Office Action Summary

10/760,253

SILVERBROOK ET AL.

DETAILED ACTION

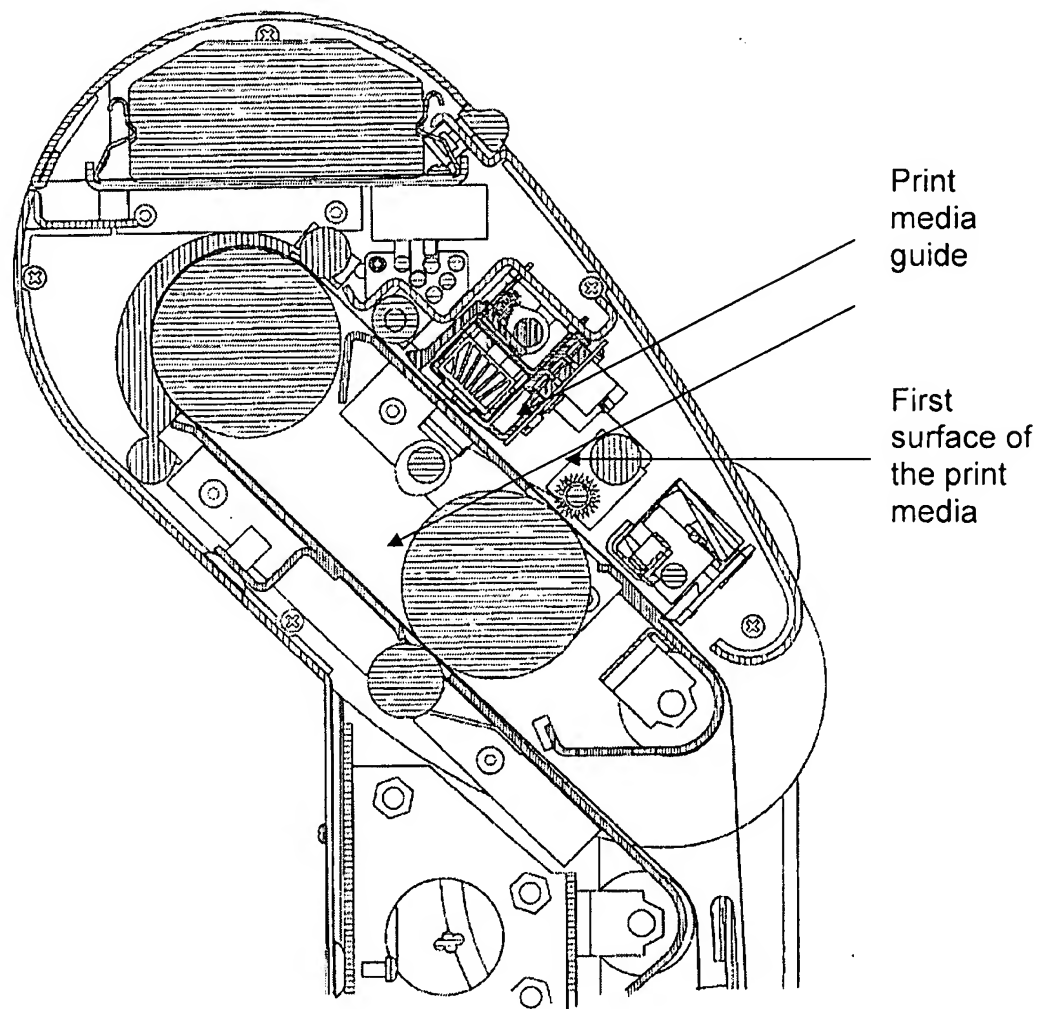
As per claim 1: a print media guide mounted to a slanted portion of the casing, adjacent the print surface, a slanted print media contact surface of the print media guide arranged to contact and guide the first surface of the print media over the print surface for printing onto the first surface (shown below).

As per claim 2: a print media guide is arranged to substantially prevent the print media from impinging on the nozzles of each of the at least two printhead integrated circuits (see figure below – media guide and rollers put pressure on paper so that it rests against the media guide and not the nozzle area).

As per claim 3: the print media guide is arranged to provide a gap between the nozzles of each of the at least two printhead integrated circuits and the passing print media (see figure below – media guide and rollers put pressure on paper so that it rests against the media guide and not the nozzle area).

It would have been obvious to one of ordinary skill in the art at the time of the invention to modify the disclosure of Silverbrook et al. with that of Silverbrook in order to improve image quality and consistency.
